HISTORIC AND DESIGN REVIEW COMMISSION

Agenda Item No: 10

HDRC CASE NO: 2015-112
ADDRESS: 268 W MARIPOSA - Detached garage
LEGAL DESCRIPTION: NCB 9013 BLK 7 LOT 11 12 AND 13
ZONING: R4 H
CITY COUNCIL DIST.: 1
DISTRICT: Olmos Park Terrace Historic District
APPLICANT: Jose Cueva
OWNER: Janet Vasquez
TYPE OF WORK: Demolish existing garage and construct small cottage
REQUEST:

PROPOSED SITE PLAN

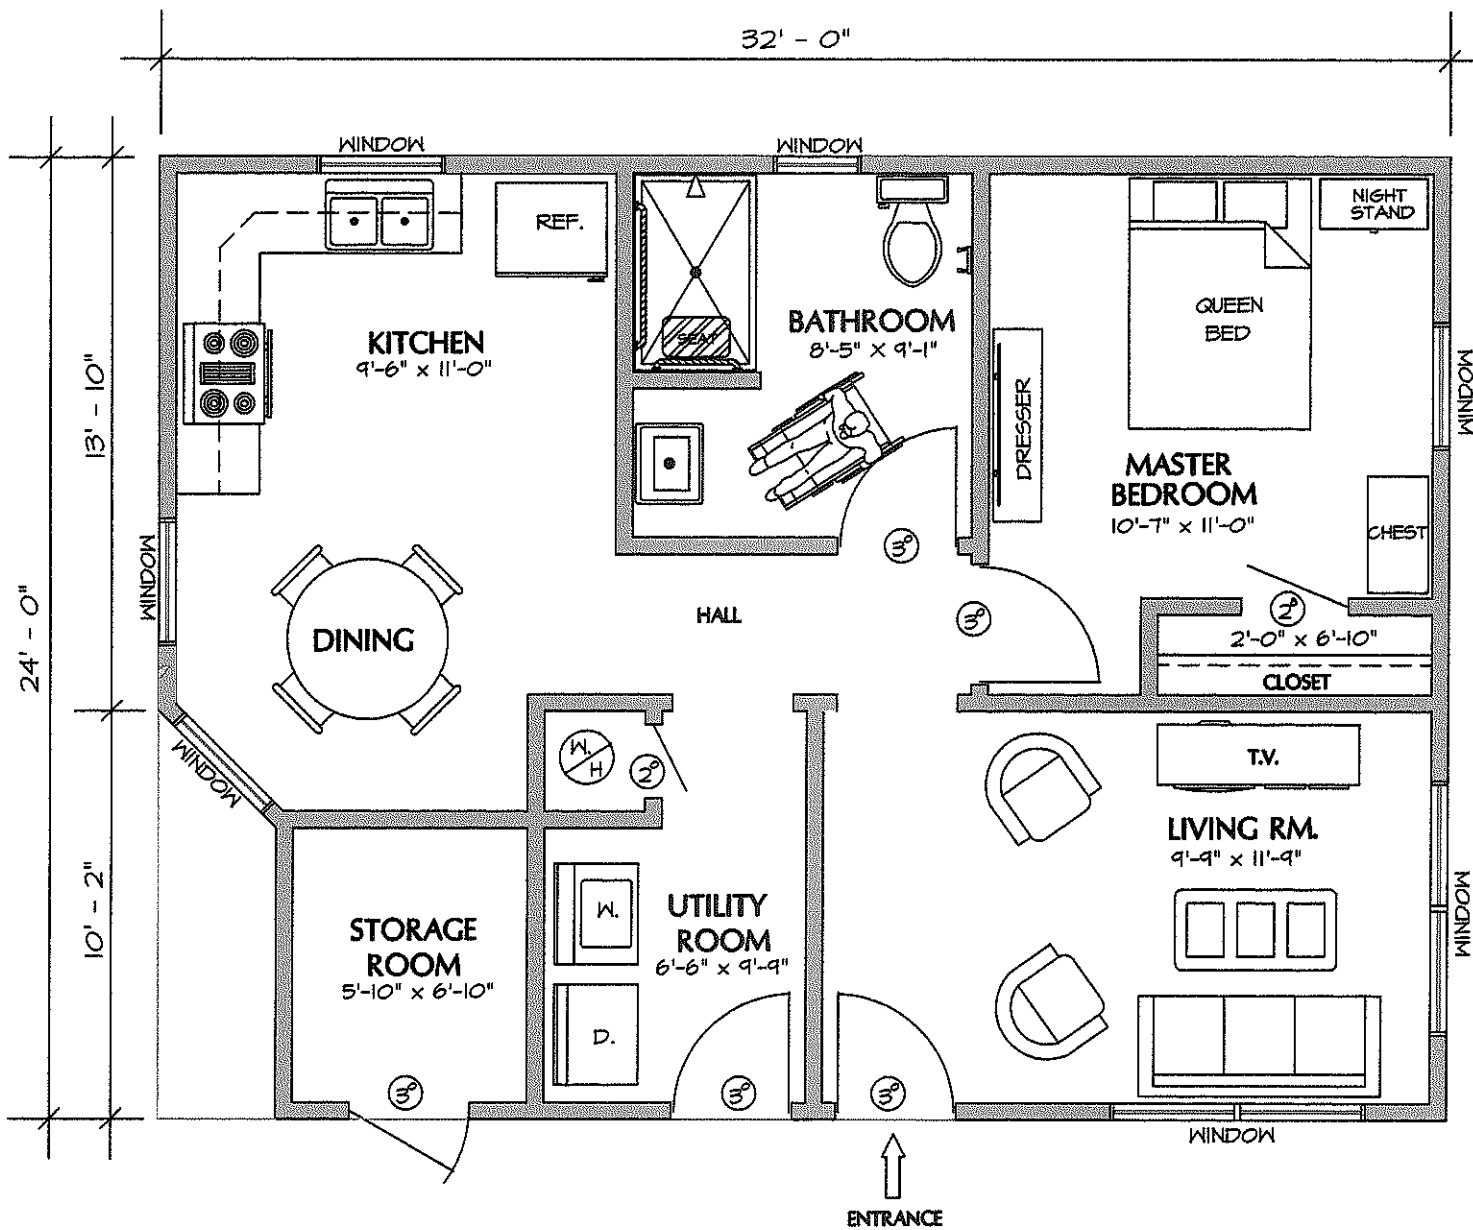
- e. According to the Guidelines for New Construction, historic setback patterns should be followed for new outbuildings. The proposed cottage will match the side setback on the existing structure and expand the rear wall to meet the rear setback. The proposed setbacks are consistent with the guidelines. However, the new structure might encroach on the side setback which may require a variance.

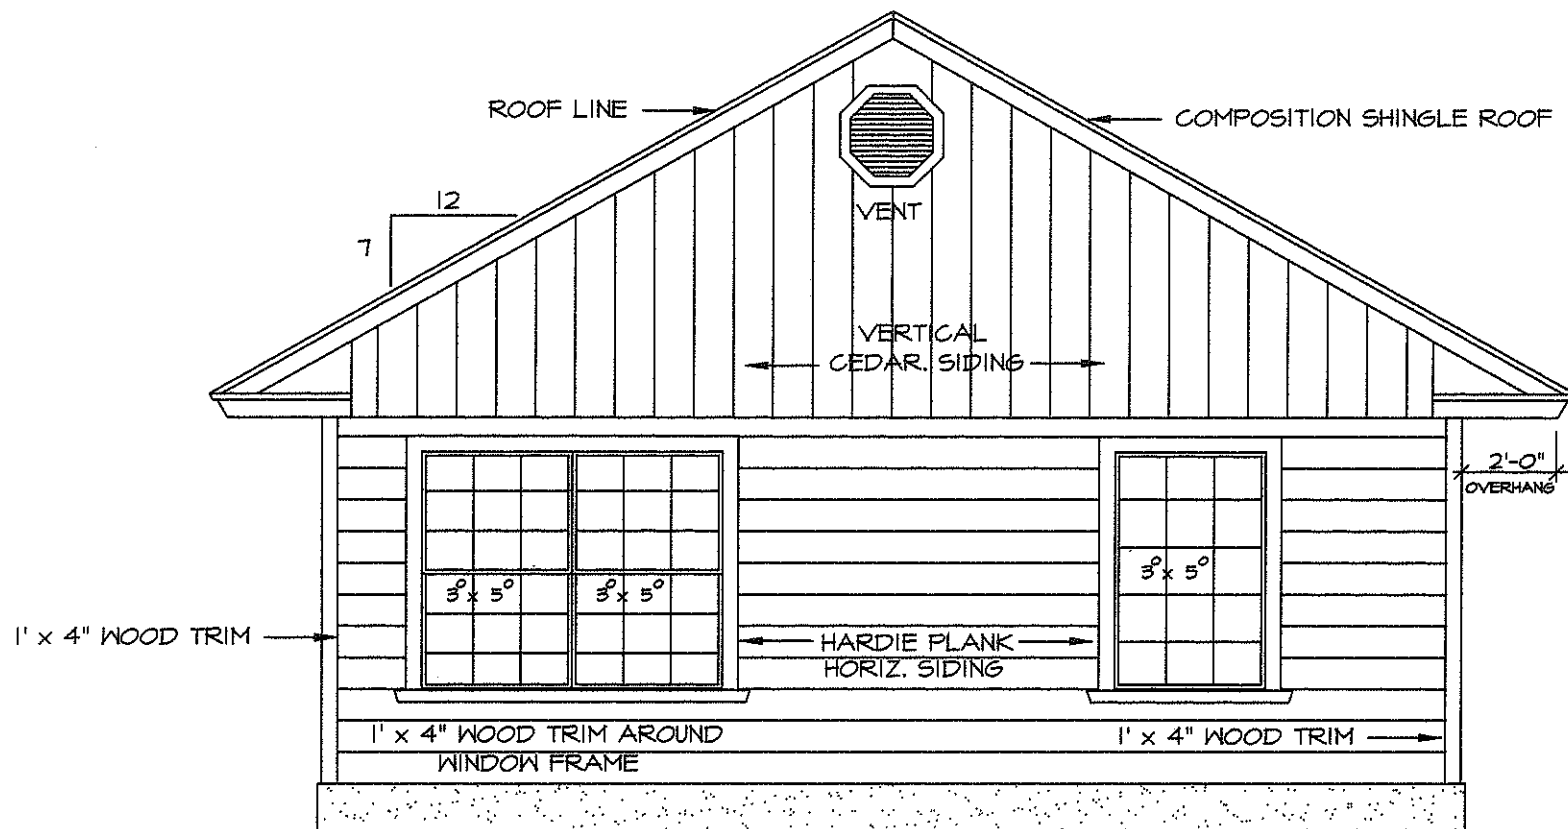
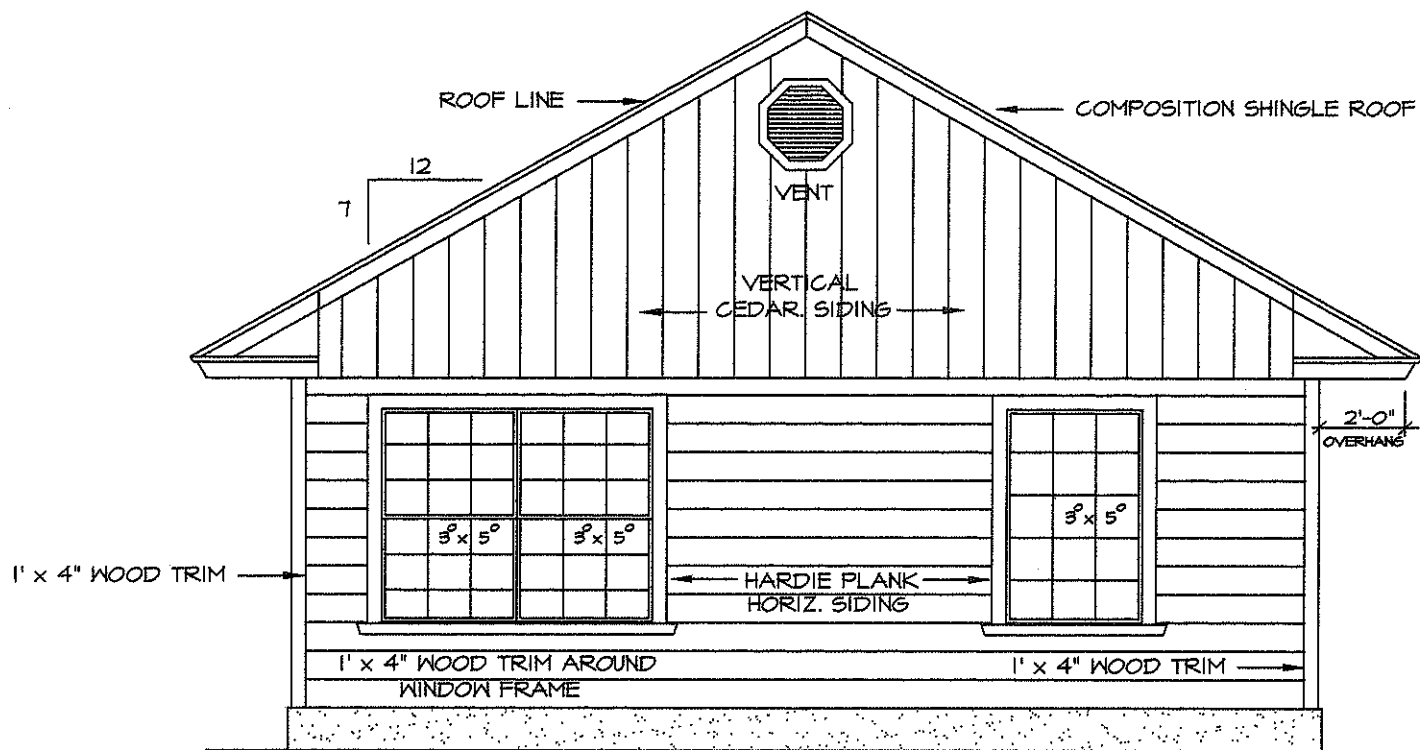
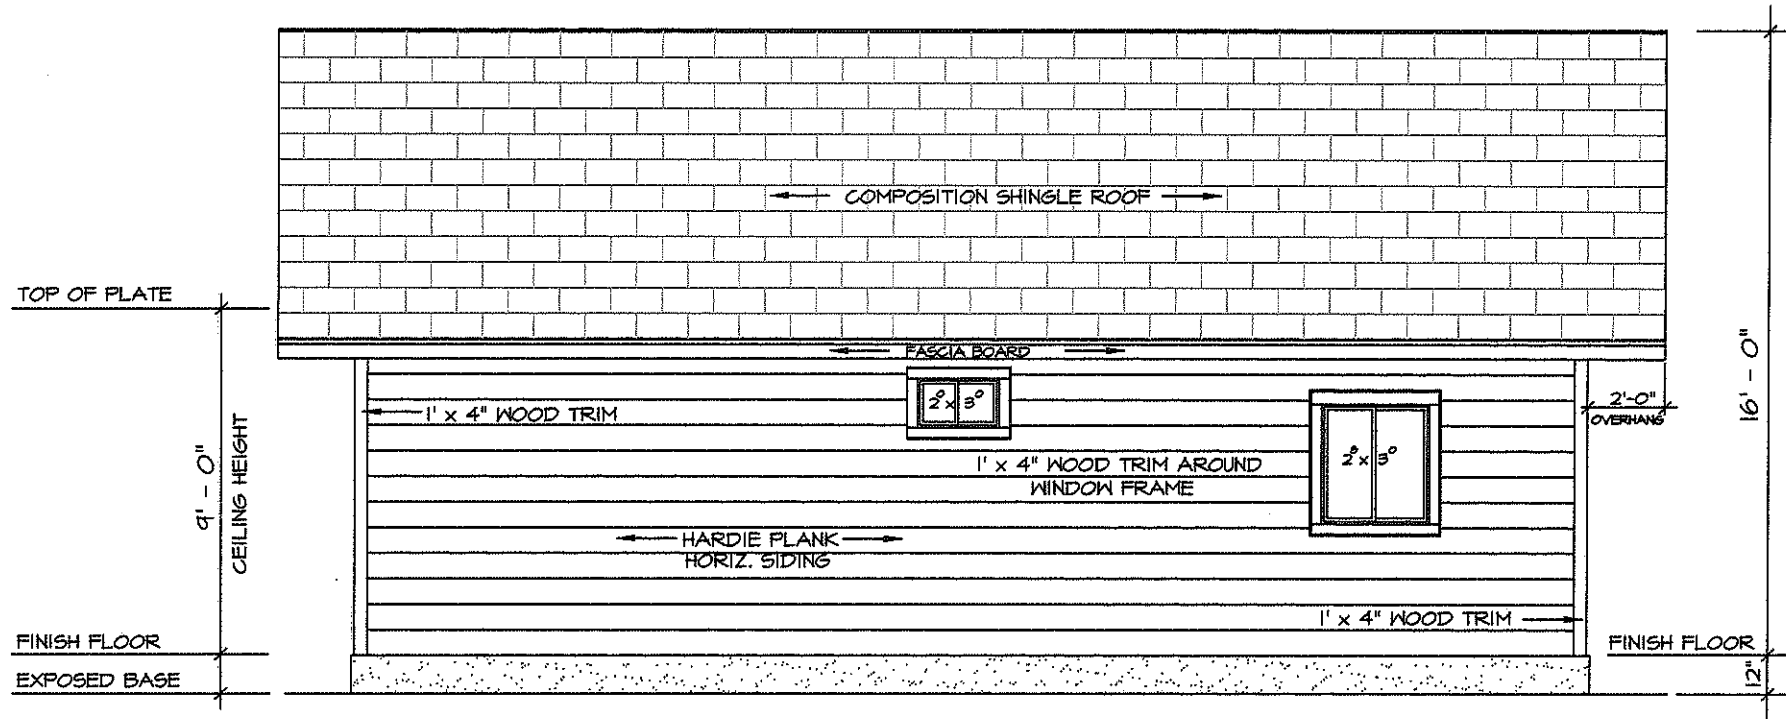
- f. The Guidelines for New Construction recommend new outbuildings to have window and door openings similar to those found on the principle structure in terms of spacing and proportions. The proposed windows are consistent in proportions to the main house. However, the proposed nine over nine aluminum windows will not match the six over six true divided lite windows on the house which should be avoided. In addition, the proposed doors are not a typically found door type in historic districts and does not relate to the historic home.

- a. A door type that is consistent with those found in historic districts is used
- b. If windows with divided lites are used, they should match the windows on the main house and use true divided glass.
